**LOG OF MEETING
DIRECTORATE FOR ENGINEERING SCIENCES**

SUBJECT: Recreational Off-Highway Vehicles (ROVs) – OPEI B71.9 Public and Stakeholder Meeting

On June 4, 2015, U.S. Consumer Product Safety Commission ("CPSC") staff received a pre-canvass draft of ANSI/OPEI B71.9-201X, *American National Standard for Multipurpose Off-Highway Utility Vehicles*.¹ Staff appreciates the opportunity to comment on the pre-canvass draft and is pleased to see OPEI taking steps to improve the voluntary standard with the addition of requirements in the areas of lateral stability, vehicle handling, and occupant protection.

Figure 2. Examples of divergent and stable lateral acceleration gain during constant steer angle test.

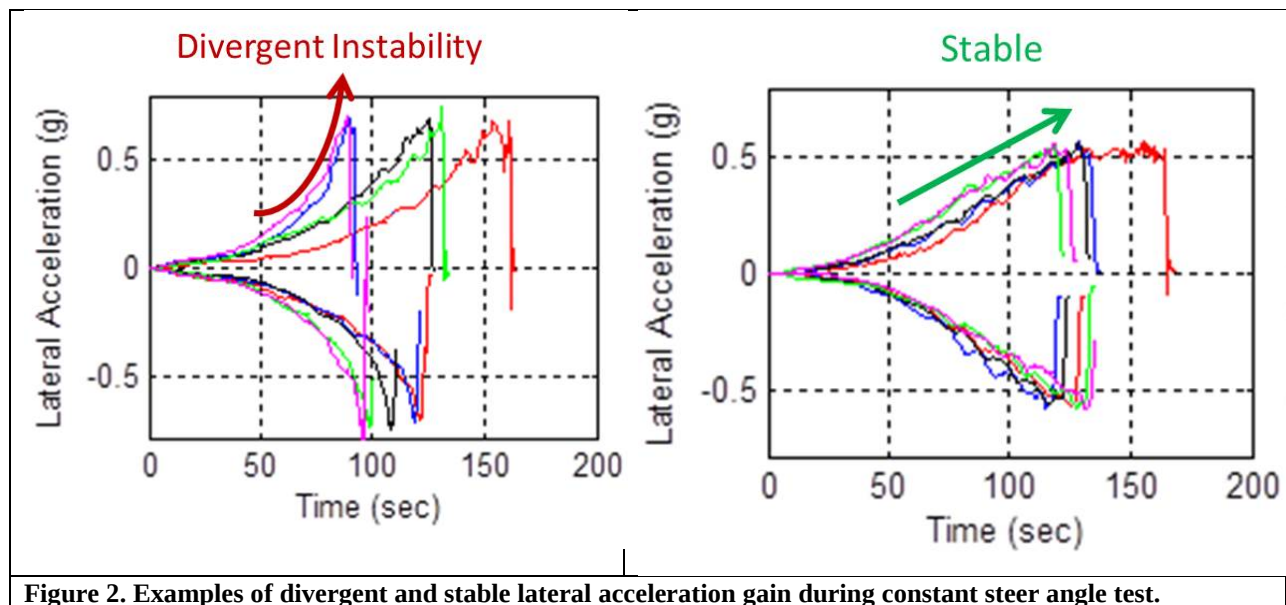
CPSC staff contracted SEA to conduct constant steer angle tests of several ROVs on a 50-foot radius circle. The test results for nine vehicles that have been tested by SEA, in accordance with the constant steer angle protocol followed by Polaris, are attached as Appendix A. Test results show that the constant steer angle test is capable of detecting divergent oversteer as a function of lateral acceleration, as shown in Figure 2. Lateral acceleration gain increase becomes asymptotic in a vehicle exhibiting divergent instability, compared to linear acceleration gain in a stable vehicle.

CPSC staff is concerned that values of 3.5 for the ratio R will allow vehicles that exhibit divergent instability to pass the vehicle handling requirement.

CPSC staff believes that a performance requirement based on the constant steer angle test can be developed to ensure ROVs do not exhibit divergent instability, if the appropriate criteria are used to determine the pass/fail performance. Staff believes four modifications to the performance criteria would further ensure ROVs do not exhibit divergent instability:

1. Add language to ensure R value that does not allow divergent instability,
2. Add language to not allow negative m_e slopes,
3. Take into account the maximum speed range of the vehicle, and
4. Modify the language to calculate the ratio separately for the left turns and right turns.

Figure 3. Examples of divergent and stable yaw rate gain during constant steer angle test.

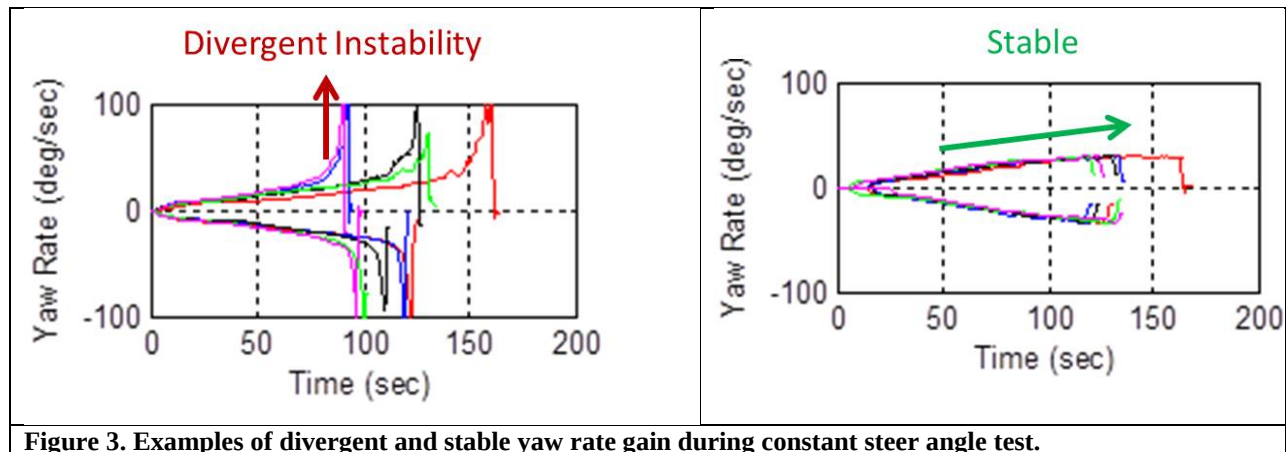
Similarly, the constant steer angle shows divergent instability as a function of yaw rate increase, as shown in Figure 3. Yaw rate gain increase becomes asymptotic in a vehicle exhibiting divergent instability compared to linear yaw rate gain in a stable vehicle.

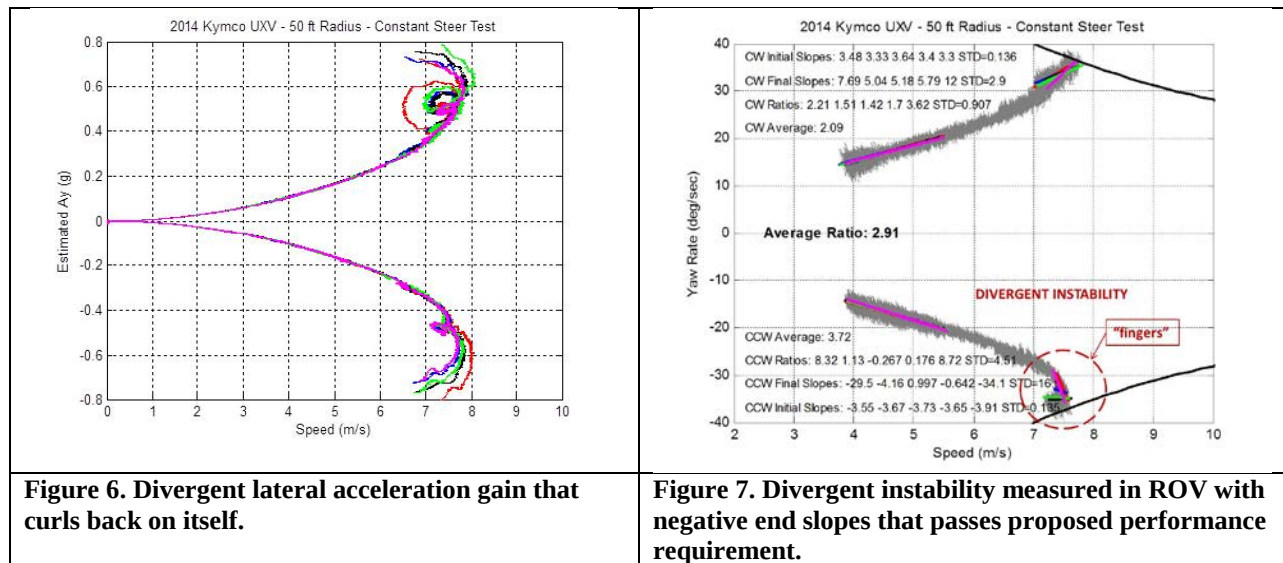
This vehicle also exhibited undesirable spin-out at approximately 20 mph at the end of the test as shown in the following video:

Staff believes that a vehicle exhibiting such an uncontrollable response is dangerous and should not pass any vehicle handling requirement. Staff agrees with OPEI's position that divergent instability is undesirable and dangerous because the vehicle may slide into a tripped rollover.¹⁴ Therefore, staff is concerned that even though the vehicle in Figure 4 shows "divergence," as originally defined by Polaris and incorporated into the OPEI Draft ballot, and exhibits spin-out during the yaw test, the vehicle passes the proposed vehicle handling requirement with an R value of 2.54.

Figure 23: Vehicle C Side View Figure 10. Vehicle C with shoulder and lap belt, without shoulder barrier.	Figure 24: Occupant C at 45° Roll Figure 11. Occupant remaining in the safety zone during a simulated roll over. Seatbelt has a tilt sensing ELR.

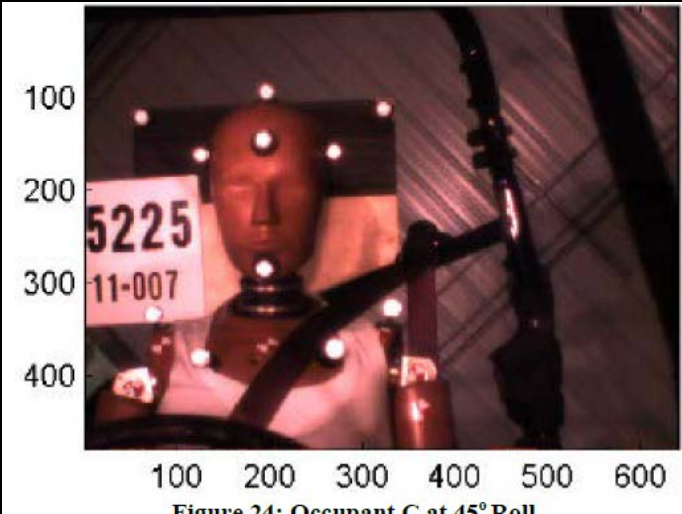
SEA roll simulator testing showed that vehicles with tilt sensing ELR performed better. Vehicle C, shown in Figure 10, does not have a passive shoulder barrier but was equipped with a tilt sensing ELR. CPSC staff test of Vehicle C shows that the seatbelt locks at approximately 53-degree tilt angle. By cross-referencing the lateral acceleration seen in the SEA sled tests with the acceleration associated with the locking angle of the inertial seat belt, the inertial spool lock engaged at approximately 10 degrees of vehicle roll. Figure 11 shows the occupant remaining in the protective zone of the ROPS during a simulated roll over.

CPSC staff believes that the combination of the belt routing, the tilt sensing ELR, and other unknown features interacted to limit occupant excursion.

CPSC staff continues to recommend passive shoulder barriers. Staff recognizes that one-hand operated doors and nets are passive, once engaged by the consumer; however, staff believes that doors are more likely to be used than nets, and staff remains concerned that nets will not be used. Roll simulation tests show that a belted occupant can come outside of the protection zone of the ROPS if a shoulder barrier is not used. Seatbelts with tilt sensing ELRs may improve occupant containment during a rollover, but SEA testing shows that the combination of a seatbelt and a shoulder restraint is the most effective configuration in retaining occupants in a rollover event. Staff is confident that passive shoulder barriers and seat belts will keep occupants contained within the vehicle. For these reasons, we continue to recommend that ROVs have passive shoulder barriers and seatbelts that limit the ROV's speed, if not used.
